Global Technical Regulation No. 7 (Head restraints)

OICA position on head restraint height

Figure S.2: Percentage probability of mitigating long-term neck injury based on head restraint height and backset for the UK male population

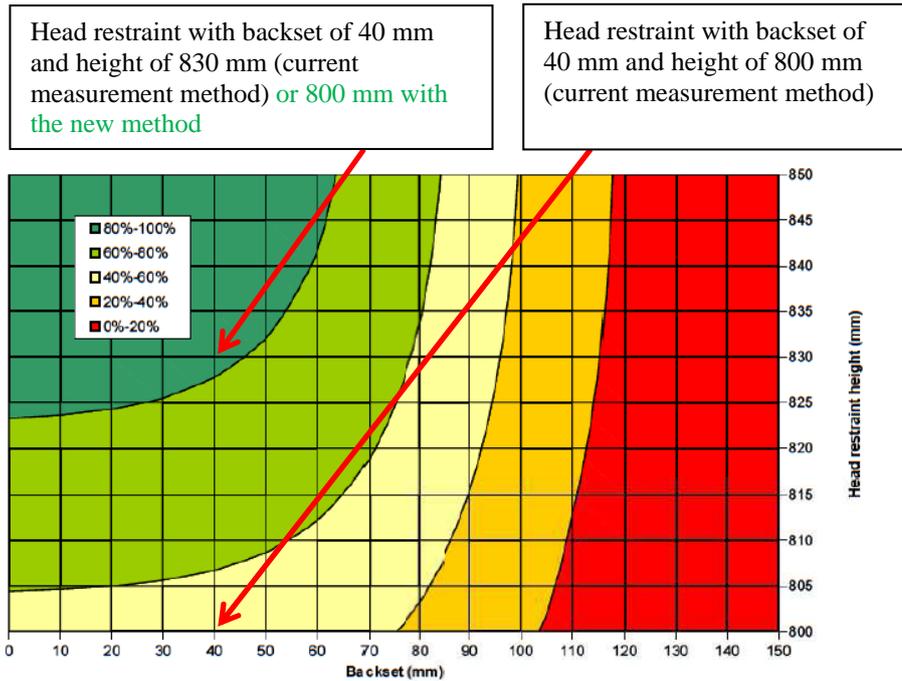
In particular, a graph (see below) summarises the injury-mitigation potential (in other words the safety benefit) of backset/height combinations. OICA herewith stresses that the head restraint heights mentioned in this graph are based on the current measurement method. Taking into the fact that simply changing the measurement method would require head restraints to be higher, it is clear that this simple change of measurement method would give results in the dark green area (80-100% probability of mitigating long term neck injury).

This means that if GTR7 is amended by incorporating the new measurement method and retaining the 800 mm limit, all head restraints meeting the requirements would be at least as good as the point indicated in the graph (dark green area).
